**TOWN OF CARRBORO  
APPEARANCE COMMISSION  
AGENDA**

**September 3<sup>rd</sup>, 2020**

SUBJECT: CLUB NOVA CUP MAJOR MODIFICATION, 103 W. MAIN STREET

**Conditional Use Permit Major Modification for Club Nova**

Site Plan - East Sidewalk - 1"=10'

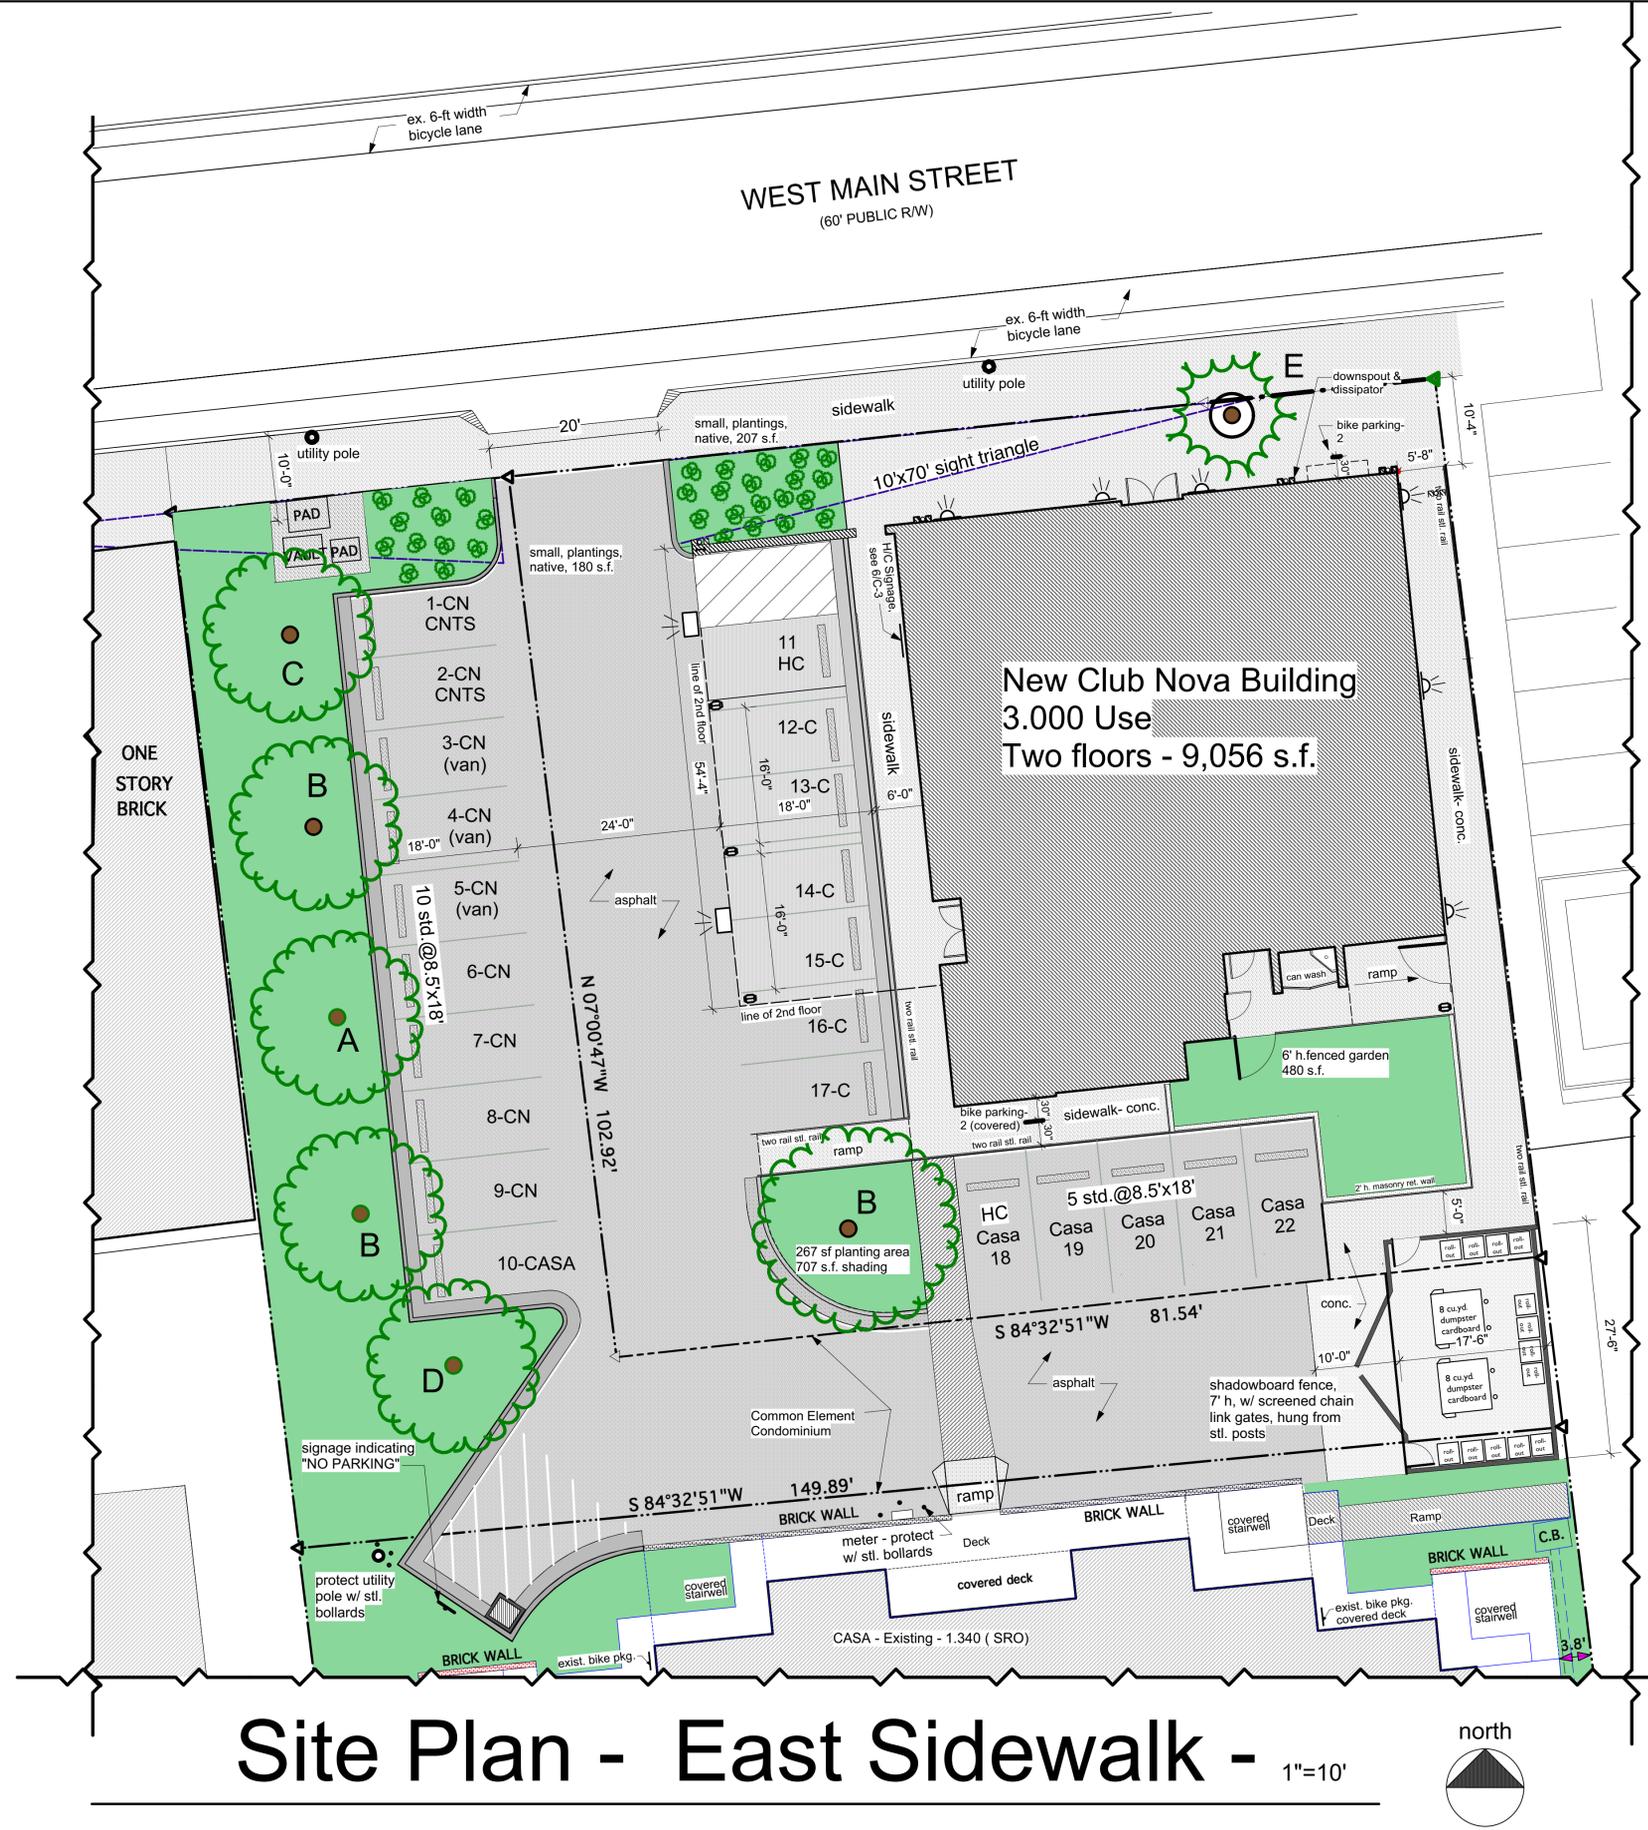
Section 15-317 of the LUO requires that 35% of vehicle accommodation areas be shaded by trees. For this project, this amounts to 35% of a VAA area of 7,750 sf or 2,713 sf. To this end, the applicant is providing 2,828 sf or about 36% (see sheet SP-1 of Attachment B).

The proposed site plan shows a sidewalk that is widened up to the edge of the right-of-way (about 8 feet) and joins with a concrete apron in front of the building (at the same grade as this sidewalk). The applicant is requesting that the lack of 10' sidewalk width in this area be allowed to remain.

1. We appreciate the work you have done on the project, including on stormwater management. We also agree with the variances you are requesting except for the request to deviate from the Vehicle Accommodation Area (VAA) shading. While the shade ordinance could likely be met from the building, the trees are doing more to combat climate change than just shading. Trees have other benefits as well, including stormwater management, improving mental health, and providing food and habitat for wildlife. The Town needs to stand by the rules that have been put in place which protect the climate.

Main St./North Elevation

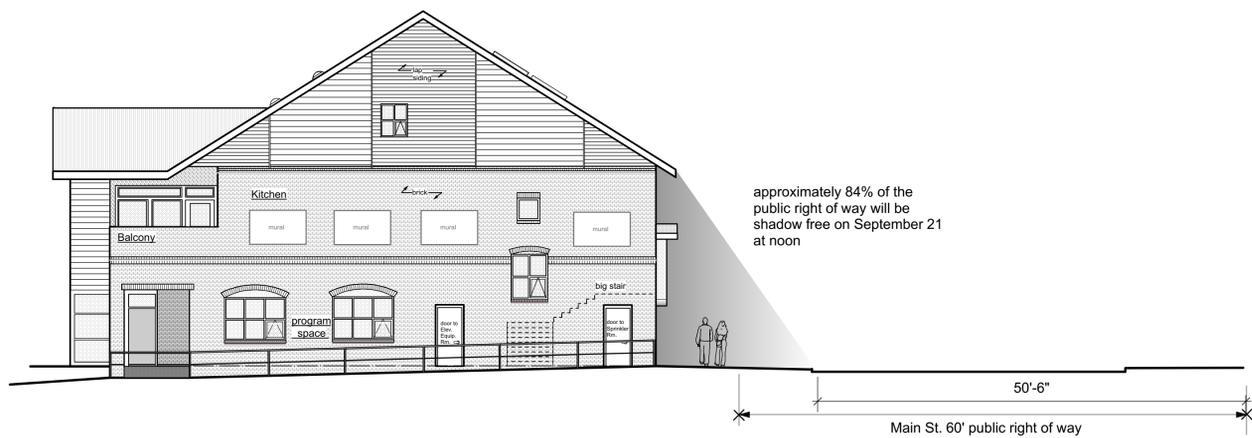
1. We certify that the plan does substantially achieve the purposes set in 15-178 (a) if and only if it is built using varying red brick shades to achieve a look in line with Carr Mill, and uses varying materials as shown in the facade drawing. We also encourage additional glazing, greenery, flowers, art, or amenities to enhance the appearance of the front to the extent possible.
